UNITED STATES PATENT AND TRADEMARK OFFICE

APPLICATION NO.	FILING DATE	FIRST NAMED INVENTOR	ATTORNEY DOCKET NO.	CONFIRMATION NO.
09/770,296	01/29/2001	Andrew Kevin McParland	50060-042	8376

Office Action Summary

FIG. 1

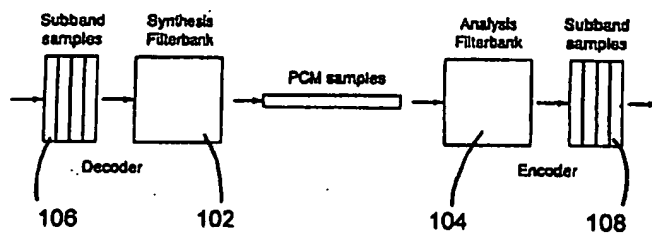
Figure 1 has been labeled as "prior art" indicating that the invention is unlikely to have any non-obvious elements.
